## TUTTLE ADDITION SUBDIVISION, BLOCK 1, RESUBDIVISION OF LOTS 4, 5, AND 6

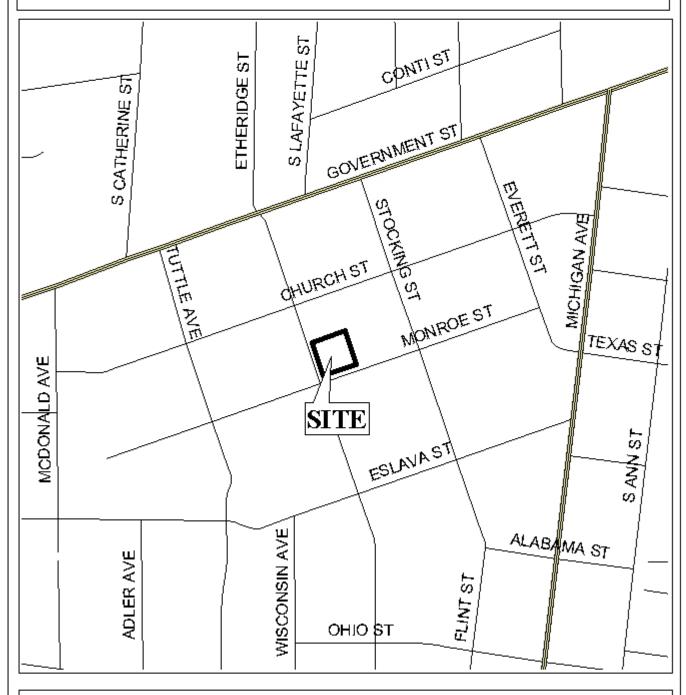
The plat illustrates the proposed 2 lot,  $0.5 \pm \text{acre}$  subdivision which is located at the Northeast corner of Dexter Avenue and Monroe Street and is in City Council District 3. The subdivision is served by public water and sanitary sewer.

The site is located in a Historic District. Typically, in a Historic District, a waiver to modify the 25-foot minimum building setback is allowed. The minimum building setback allowed for this site shall be between 16' and 21' for the front and no less than 2' for the side street; thus in compliance with the Historic District Overlay.

The plat meets the minimum requirements of the Subdivision Regulations and is recommended for Tentative Approval subject to the following condition: 1) the Historic District Overlay setbacks shown on plat.
